# Access Compliance Report

## Public Rights-of-Way

### (Curb Ramps)

Intersection ID: N/A	Main Street: E_4TH_ST	Cross Street: S_CALDWELL_ST	Location: E
ADA ID: B62B4E387BFD	Ramp Type: Perp	Initial Pass/Fail: Fail	Overall Compliance: No
		Severity Score: 35

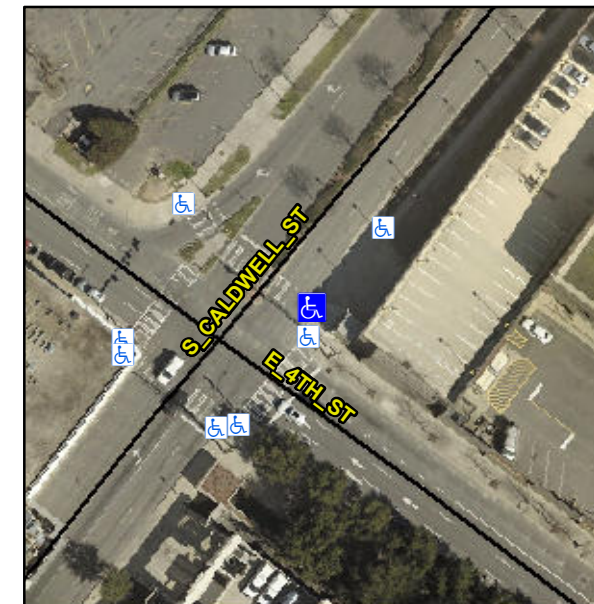
**Not Found, R304.5.1**

Compliance	Description	Data	Compliance	Description	Data
N/A	Ramp Length (in)	112.0	Yes	Ramp Slope (%)	7.4
No	Ramp Width (in)	24.0	Yes	Ramp XSlope (%)	0.5
N/A	Flare Type LT	N/A	N/A	Flare Type RT	N/A
N/A	Flare Slope LT (%)	N/A	N/A	Flare Slope RT (%)	N/A
N/A	Flare Traversable LT?	No	N/A	Flare Traversable RT?	No
N/A	Landing Length (in)	N/A	N/A	DWS Provided?	N/A
N/A	Landing Width (in)	N/A	N/A	DWS Contrast?	N/A
N/A	Landing Slope (%)	N/A	N/A	DWS Length (in)	N/A
N/A	Landing X Slope (%)	N/A	N/A	DWS Full Width?	N/A
N/A	Landing Curb? (Y/N)	N/A	N/A	DWS Offset (in)	N/A
N/A	Shared Landing?	N/A			
N/A	Gutter Ponding?	N/A	N/A	Gutter Slope (%)	N/A
N/A	Gutter Lip Ht (in)	N/A	N/A	Gutter X Slope (%)	N/A
N/A	Painted X Walk1?	Yes	N/A	Painted X Walk2?	N/A
	X Walk 1 Direction	To NW		X Walk 2 Direction	N/A
N/A	X Walk 1 Width (in)	120.0	N/A	X Walk 2 Width (in)	N/A
	X Walk 1 Slope (%)	1.6		X Walk 2 Slope (%)	N/A
	X Walk 1 X Slope (%)	2.1		X Walk 2 X Slope (%)	N/A

**Remove & Replace Entire Ramp.**
